SERVICE No. 235 BULLETIN

Piper Aircraft Corporation

SUBJECT: Standardization of Never-To-Exceed Airspeed Limit

MODELS AFFECTED: PA-30 Twin Comanche, Serial Nos. 30-853, 30-902 to 30-1080 incl., 30-1082 to 30-1136 incl., 30-1138 to 30-1198 incl., 30-1200 to 30-1217 incl., 30-1219 to 30-1226 incl., 30-1228 to 30-1253 incl.

**PLACARD
PART NUMBER SK-1835**

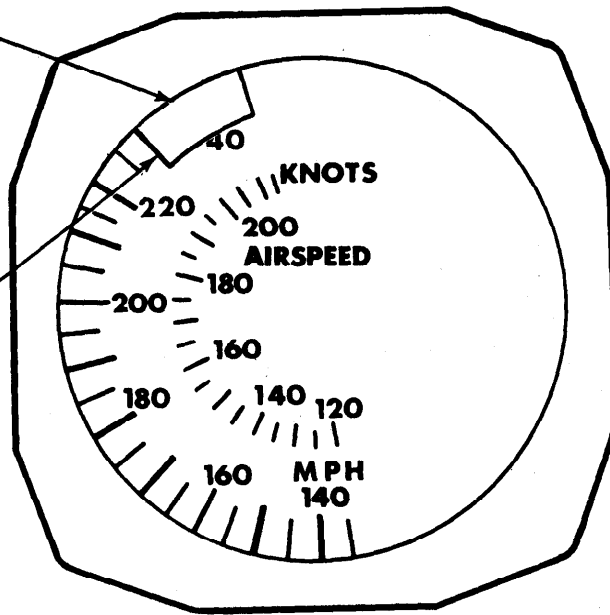
The installation of various optional equipment and S.T.C. approvals in the above referenced basic aircraft has made it desirable to standardize the never-to-exceed airspeed limit. The new never-to-exceed airspeed limit is 230 MPH.

Information concerning the installation of the airspeed placard is contained on the sketch on the reverse side of this bulletin.

**LOCATE THIS EDGE
OF PLACARD AT
230 MPH**

A placard for the airspeed indicator, part number SK-1835, and a revised Flight Manual, Piper Report No. 1269 dated August 31, 1966 reflecting this change are available through your Piper distributor.
